**SUBJECT:** Calvert Cliffs Nuclear Power Plant  
Independent Spent Fuel Storage Installation; Docket No. 72-8  
License Amendment Request: High Burnup NUHOMS<sup>®</sup>-32PHB Dry Shielded  
Canister and Horizontal Storage Modules

### **EVALUATION OF THE PROPOSED CHANGE**

Figure 3, Proposed 132 HSM ISFSI Arrangement

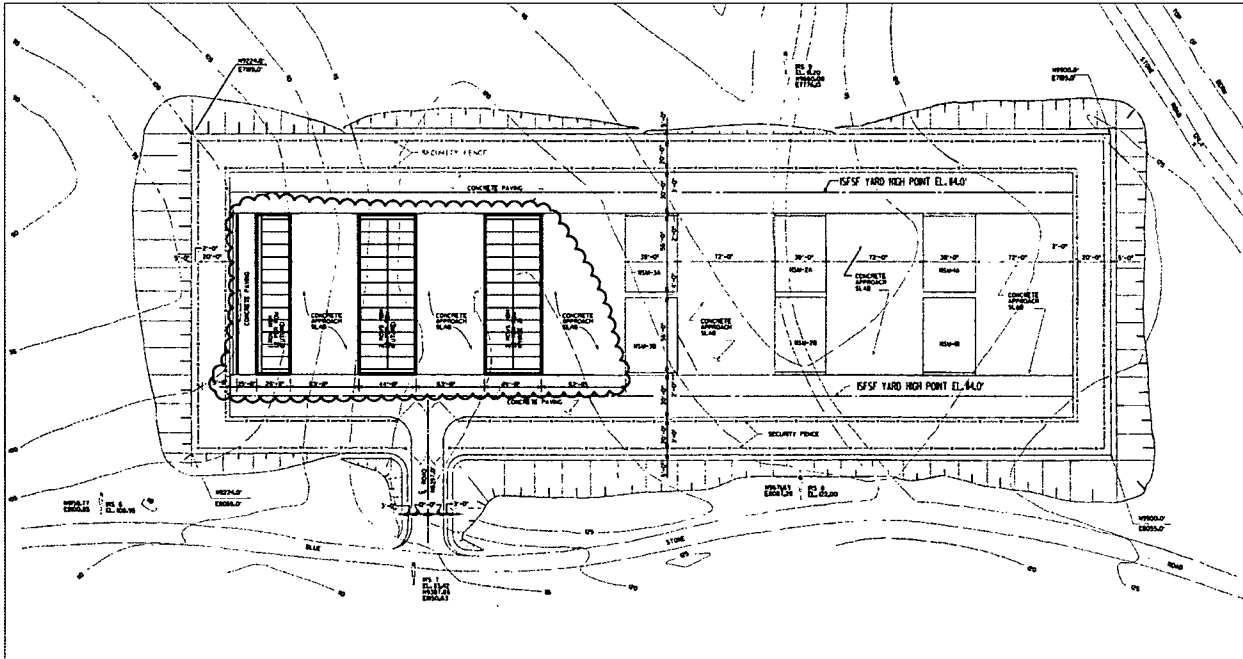
The minimum distance between the fronts of the future 2x12 phases of modules is reduced from 72 feet to 52 feet based on the maneuverability of the transfer cask transporter, creating room for an additional 1x12 array of HSM-HB modules at the south end of the existing ISFSI site. In this manner, the size of the facility may be increased from the current 120 modules (shown in Figure 2) to the 132 modules required for 60 years of power plant operation (shown in Figure 3).

Figure 4 – NUHOMS<sup>®</sup>-32PHB DSC Maximum Heat Load Zone Configuration

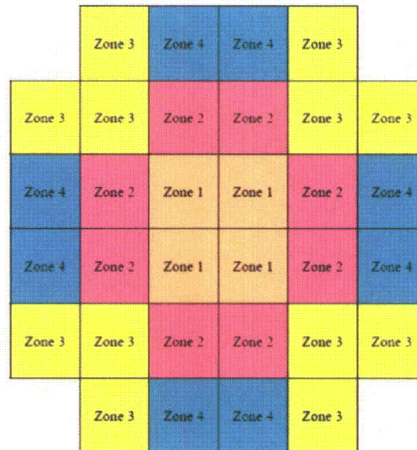
The current maximum heat generation rate limit is 0.66 kW per fuel assembly for the NUHOMS<sup>®</sup>-24P and NUHOMS<sup>®</sup>-32P DSCs. The proposed amendment would add a new maximum heat generation rate of 0.8 kW per fuel assembly for NUHOMS<sup>®</sup>-32PHB DSC basket zones 1 and 4, and a maximum heat generation rate of 1.0 kW per fuel assembly for NUHOMS<sup>®</sup>-32PHB DSC basket zones 2 and 3 (see Figure 4). Zoning is used in combination with time limits on certain loading operations to accommodate the maximum total NUHOMS<sup>®</sup>-32PHB DSC heat loads up to 29.6 kW while maintaining fuel cladding and DSC component temperatures below their respective design limits. NUHOMS<sup>®</sup>-32PHB DSCs with total heat loads of 25.6 kW (limit of 0.8 kW per fuel assembly for all zones) or 23.04 kW (limit of 0.72 kW per fuel assembly for all zones) may utilize longer time limits as discussed below. Appropriate discharge cooling times have been determined for fuel assemblies to be loaded into a NUHOMS<sup>®</sup>-32PHB DSC and will be added to USAR Table 9.4.1. The current maximum heat generation rate for the NUHOMS<sup>®</sup>-24P and NUHOMS<sup>®</sup>-32P DSCs remain the same.
